PIC16C924 Rev. A Silicon/Data Sheet Errata

The PIC16C924 (Rev. A) parts you have received conform functionally to the Device Data Sheet (DS30444E), except for the anomalies described below.

FIGURE 1: SCK PULSE VARIATION USING TIMER 2/2

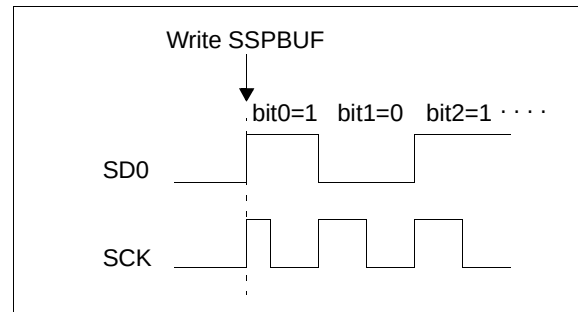
When the SPI is using Timer2/2 as the clock source, a shorter-than-expected SCK pulse may occur on the first bit of the transmitted/received data (see Figure 1).

To avoid producing the short pulse, turn off Timer2 and clear the TMR2 register, load the SSPBUF with the data to transmit, and then turn Timer2 back on. Refer to Example 2 for sample code.

FIGURE 1: WRITES TO TIMER1 (EXTERNAL CLOCK / OSCILLATOR MODE)

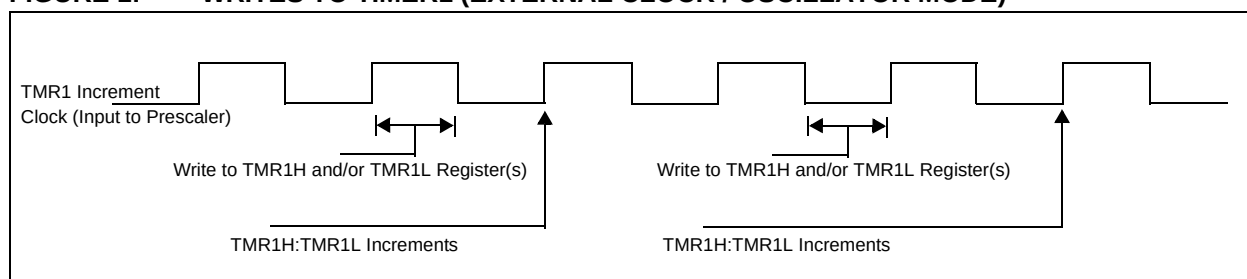
The operation of Timer1 needs some clarification when the timer registers are written and the TMR1ON bit is set.

The internal clock signal that is the input to the TMR1 prescaler affects the incrementing of Timer1 (TMR1H:TMR1L registers and the Timer1 prescaler). When the Timer1 registers are NOT written, the Timer1 will increment on the rising edge of the TMR1 increment clock.

When the TMR1H and/or TMR1L registers are written while this clock is high, TMR1 will increment on the next rising edge of this clock.

When the TMR1H and/or TMR1L registers are written while this clock is low, TMR1 will not increment on the next rising edge of this clock, but must first have a falling clock and then the rising clock for TMR1 to increment.

Figure 1 shows the two cases of writes to the TMR1H and/or TMR1L registers. Due to the V_{IH} and V_{IL} thresholds on the oscillator/clock pins, external Timer1 oscillator components, and external clock frequency, the Timer1 increment clock may not be of a 50% duty cycle.

The TMR1 increment clock is out of phase of the T1OSO/T1CKI pin by a small propagation delay.

FIGURE 2: PORTC BLOCK DIAGRAM (PERIPHERAL OUTPUT OVERRIDE)

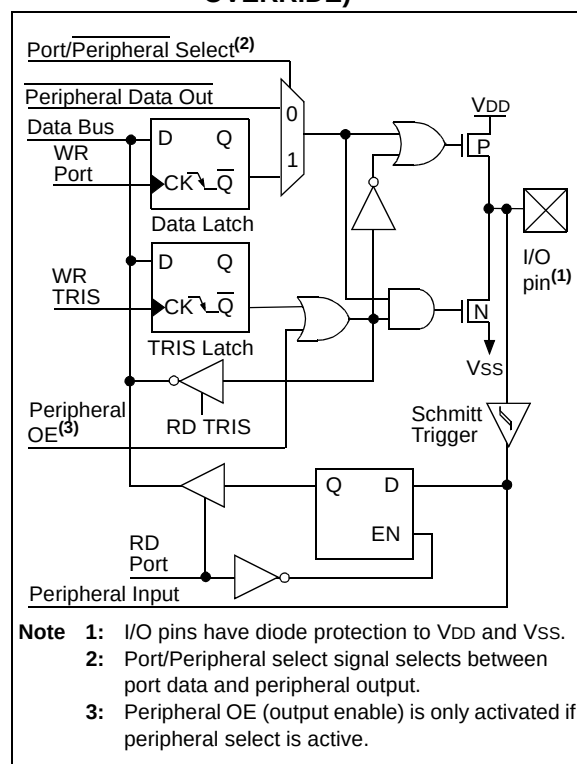
The block diagram for PORTC presented in Figure 5-5 of the Device Data Sheet (DS30444E) is incorrect. The correct block diagram is shown in Figure 2.

FIGURE 3: WAVEFORMS IN 1/2 MUX, 1/3 BIAS DRIVE

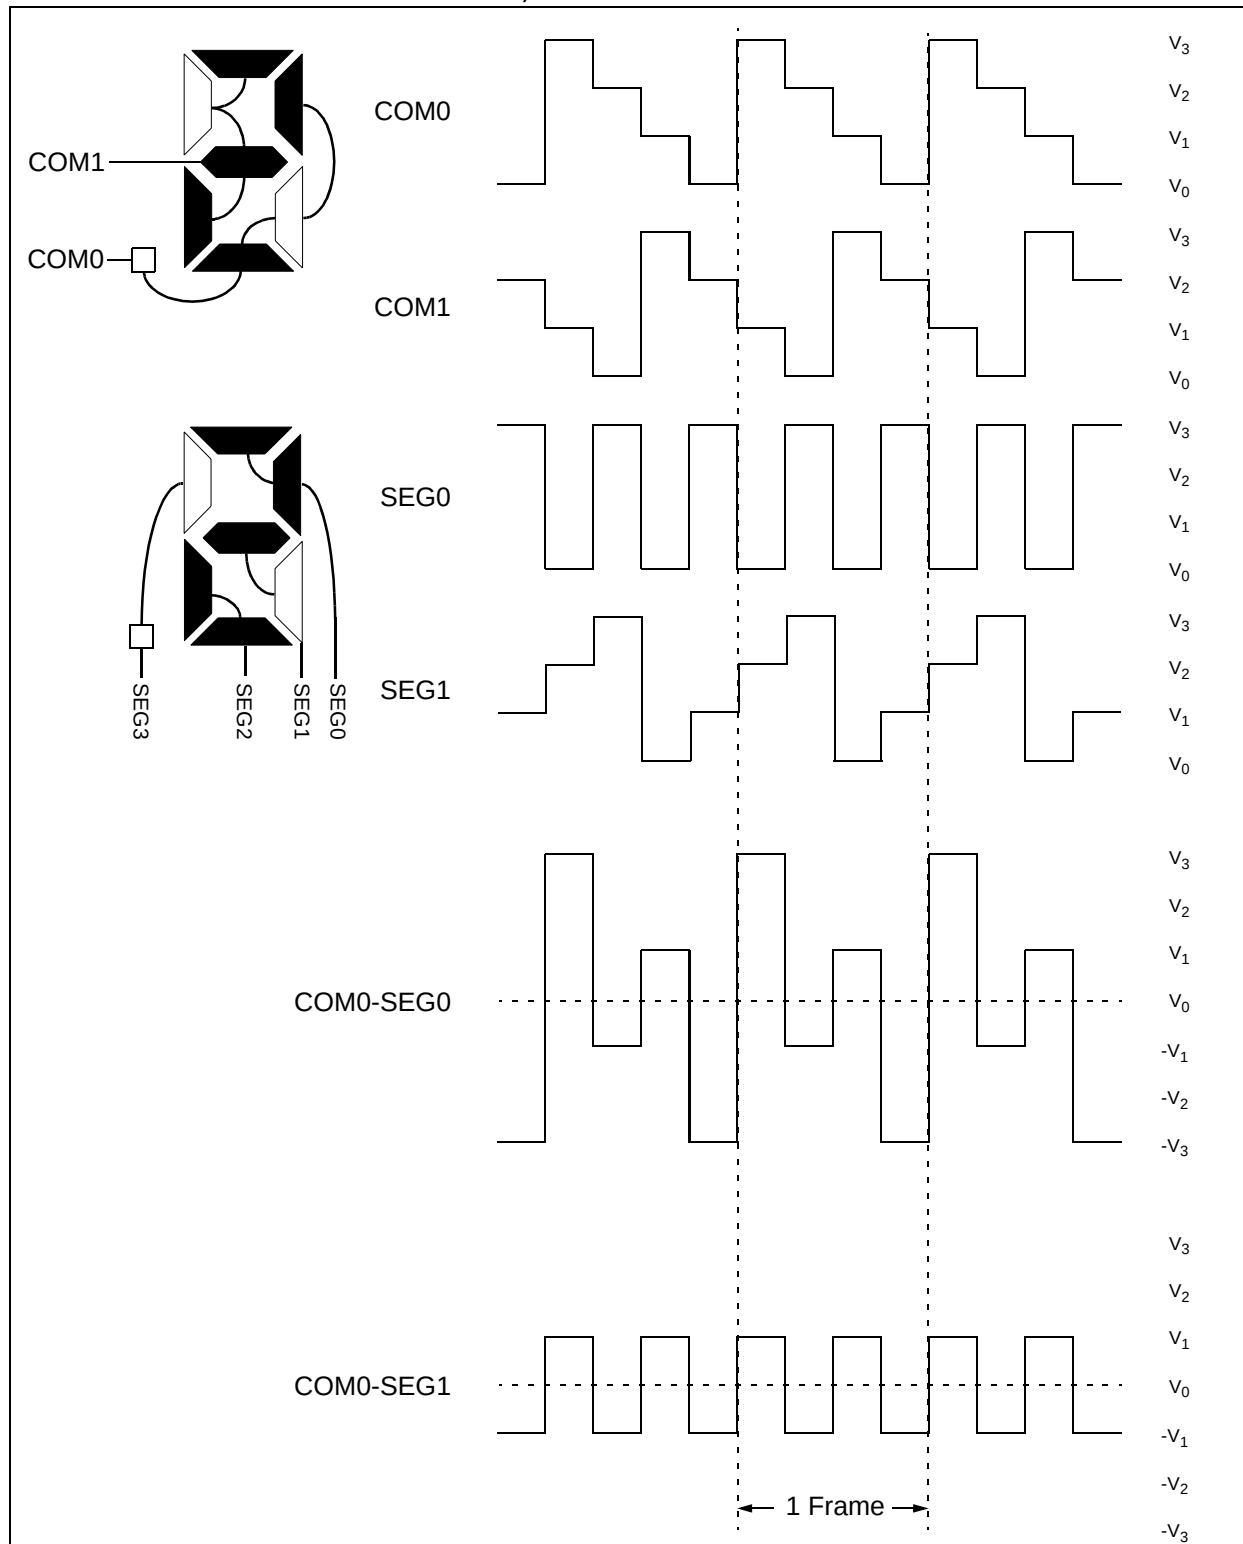
Figure 13-5 in the data sheet, depicting drive waveforms in 1/2 multiplex, 1/3 bias mode, is incorrect. Specifically, the connections for the

different LCD segments (SEG0 through SEG4) and the SEG1 drive waveform have been changed. The correct diagrams and waveforms are shown in Figure 3.
